FUTURE CLOTHING LTD.

DURGAPUR, MONDOLBARI, ZIRABO, ASHULIA, SAVAR, DHAKA
(23.903727, 90.303310)
18 July 2022

RSC RMG SUSTAINABILITY COUNCIL

Shed-1 (Sewing)

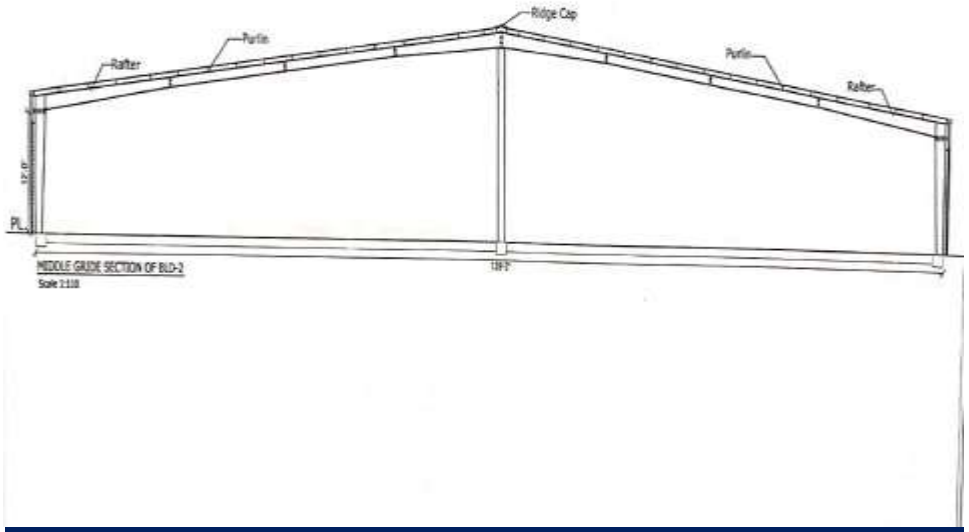
As per BNBC, every building or structure designed shall have its design documents prepared in accordance with the provision of Section 1.9.1. The design document shall include a design report, and a set of structural drawings, which shall be prepared in compliance with section 1.9.1.1 and section 1.9.1.2 as per BNBC. At the time of inspection design report was not available. Factory engineer is required to prepare the design report in compliance with section 1.9.1.1 (part-6, BNBC).

Section provided with no dimension of members

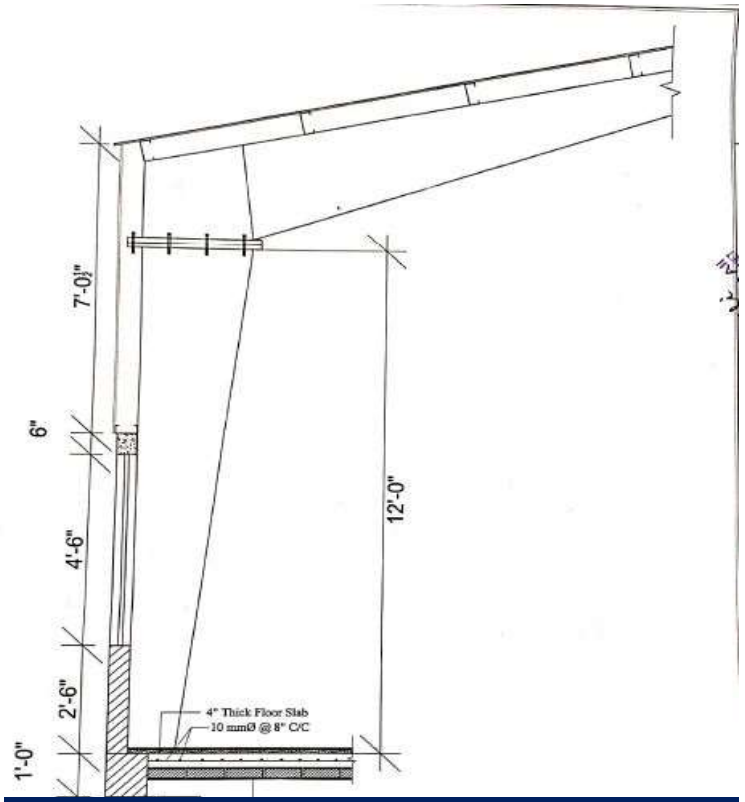
Steel section was shown in as-built drawing, but no dimension of steel members was mentioned. Also, no bracing layout included in as-built drawing. Factory engineer is required to prepare the full set of as-built drawing in compliance with section 1.9.1.2 (part-6, BNBC).

No canopy shown in as-built drawing

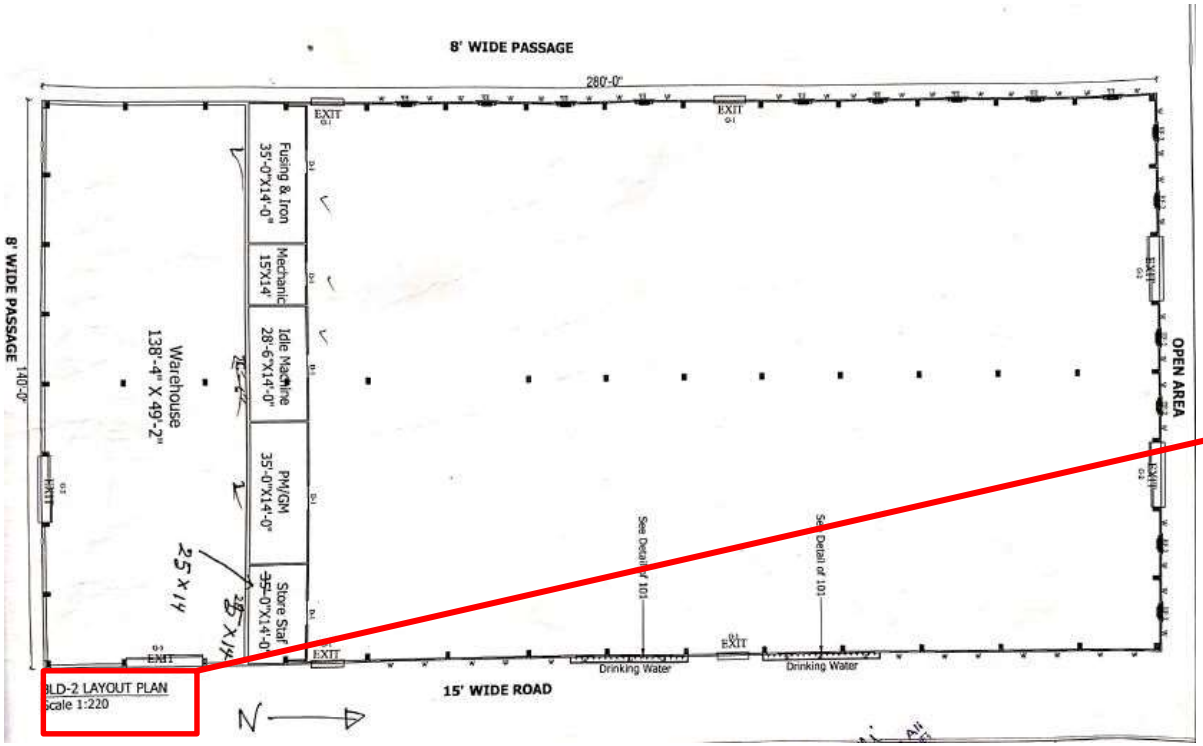
A structurally connected canopy observed at marked location which was not shown in as-built drawing. Factory engineer is required to survey the whole structure and prepare accurate as-built drawing.

Shed 04 (Wash Sent)

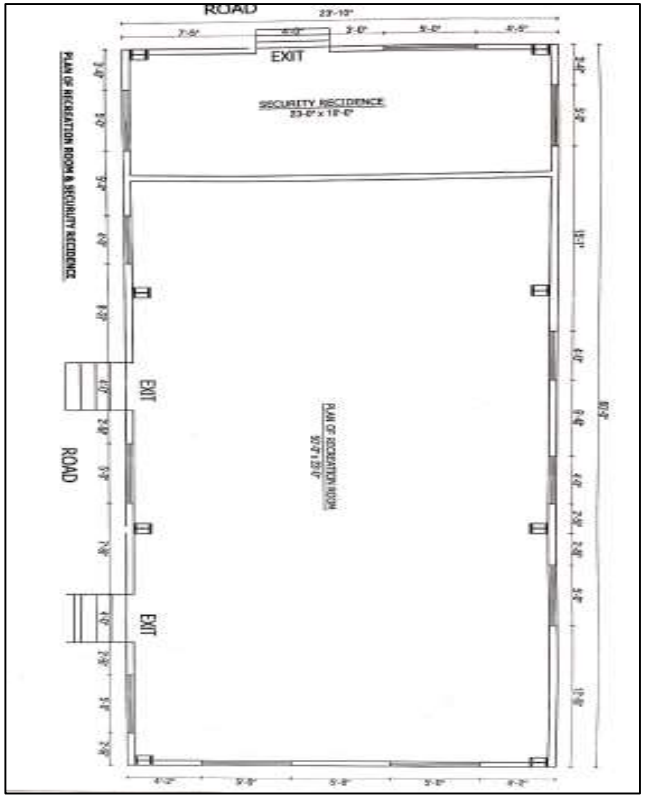
As per BNBC, every building or structure designed shall have its design documents prepared in accordance with the provision of Section 1.9.1. The design document shall include a design report, and a set of structural drawings, which shall be prepared in compliance with section 1.9.1.1 and section 1.9.1.2 as per BNBC. At the time of inspection design report was not available and only a floor layout was available which are required to be prepared in compliance with section 1.9.1.1 and section 1.9.1.2 (part-6, BNBC).

Shed-6 (Utility)

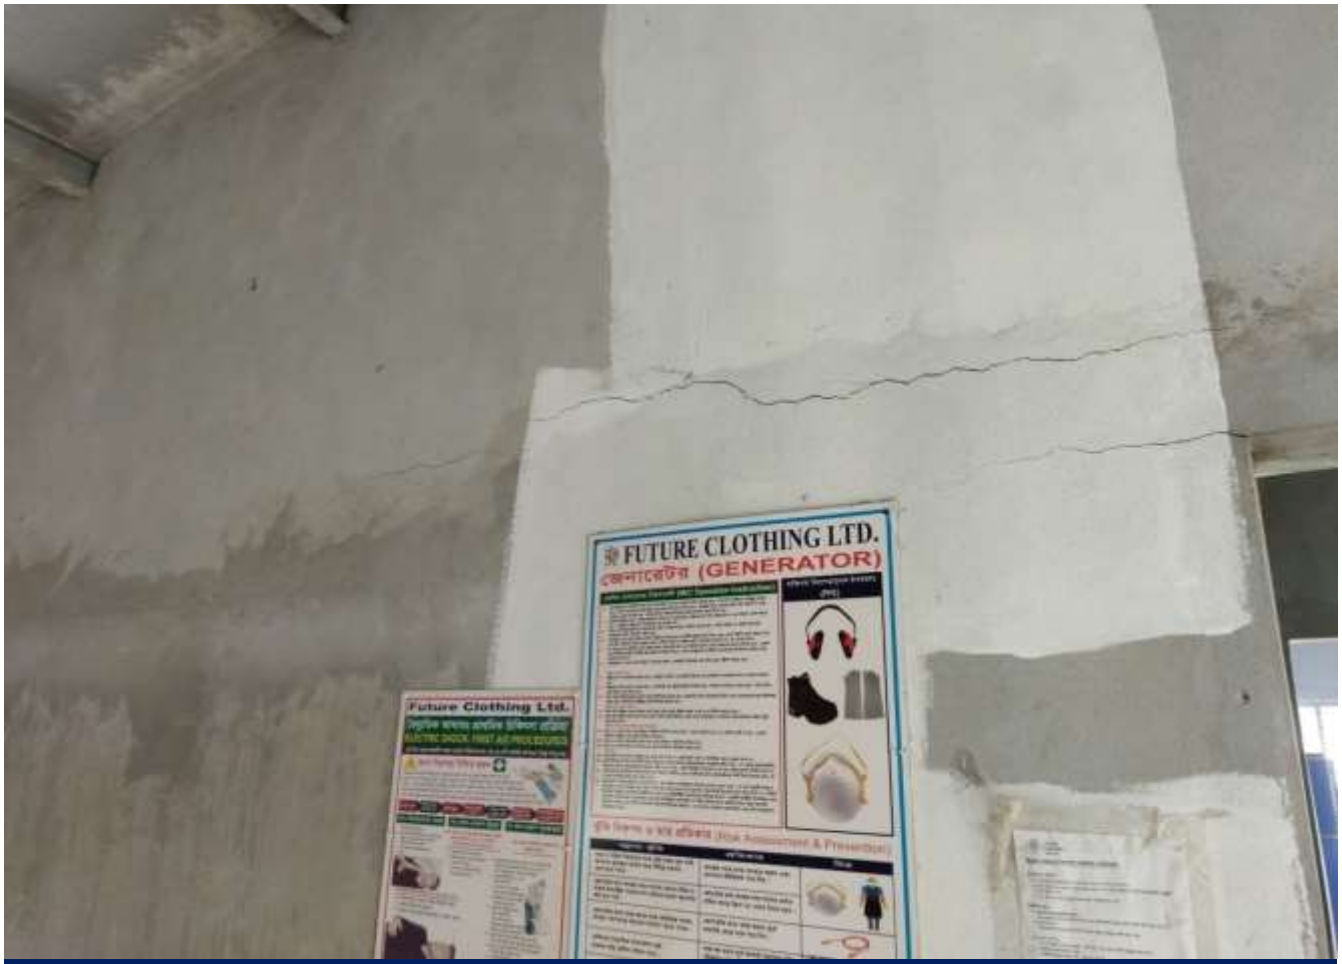
As per BNBC, every building or structure designed shall have its design documents prepared in accordance with the provision of Section 1.9.1. The design document shall include a design report, and a set of structural drawings, which shall be prepared in compliance with section 1.9.1.1 and section 1.9.1.2 as per BNBC. At the time of inspection design report was not available which is required to be prepared in compliance with section 1.9.1.1 (part-6, BNBC).

Shed 07 (Compressor Room)

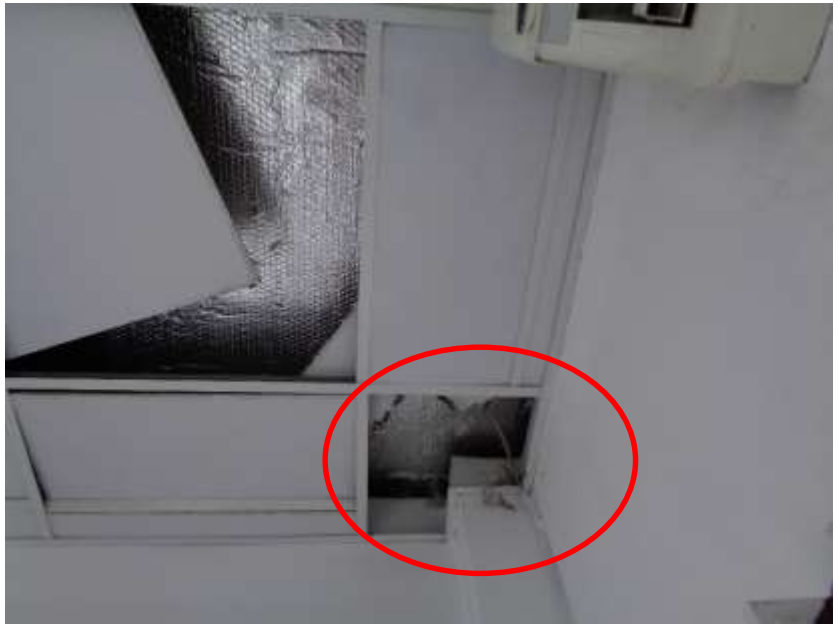
As-built drawing of this structure was not available at the time of inspection. Factory engineer is required to prepare full set of as-built drawing as per 1.9.1.2 (BNBC)

Steel members (both purlin and truss) are welded with rebars of columns without any joint plate which is appeared to be inadequate. Factory engineer is required to check the connection adequacy for uplift forces as a part of EA and implement remediation work where required.
